## TECHNICAL MEMORANDUM

DATE: Saturday, September 08, 2012  
TO: Michele Koehler, Seattle Public Utilities  
FROM: Derek Booth, Stillwater Sciences  
SUBJECT: Meadowbrook Pond conceptual analysis for sediment-related issues

A schematic of the pond has been provided by Seattle Public Utilities (SPU), including locations of field photos referenced in the next section (red numbers):

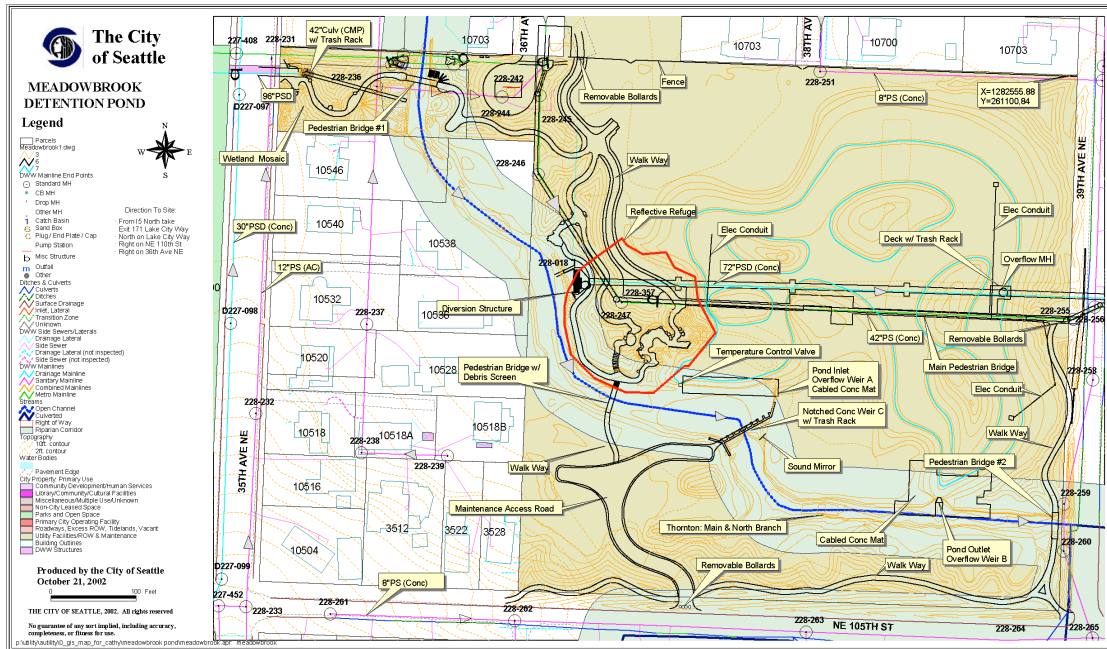
The primary goal of any reconfiguration is presumably to induce more sediment deposition. This would be most effective during that period when the majority of the sediment load is being transported, namely during the wintertime, and at the site of most abrupt reduction in flow velocity, namely in the forebay upstream of Weirs A and C. Deposition of sediment in this area would be encouraged by the following types of measures:

- Ensuring minimal backwater in the channel of Thornton Creek upstream of the forebay (this is presumed, but information is needed).
- Blocking the upstream diversion structure inlet, on the assumption that the capacity of the Thornton Creek channel downstream to the pond is no less than its capacity immediately upstream (and so flow splitting is not needed to safely convey flows in the channel).

- Increasing the separation between the trash rack at the forebay entrance and Weir C, by increasing the size of the forebay.
- Constructing a baffle to block direct flow-through (i.e., "short-circuiting") from the trash rack to Weir C. If effective, this would have the consequence of further starving the bypass channel of the creek of most sediment, which in turn might lead to some greater degree of bank erosion in the reach downstream to 39<sup>th</sup> Avenue NE (i.e., between Photo 5 and Photo 8). This is not anticipated to be a severe problem (because only modest volumes of sediment are presumed to move down this channel at the present time) but the potential should be investigated.

- Raising the level of Weir A to increase the dead storage in the forebay. This effect would need to be balanced against the increase fraction of flow that would be diverted through

Weir C and down the bypass channel of Thornton Creek, whose capacity and/or erosional stability would need further investigation.

- Deepening the forebay to increase sediment storage, depending on whether a deeper dredging might result in any stability problems for the banks and adjacent structures.
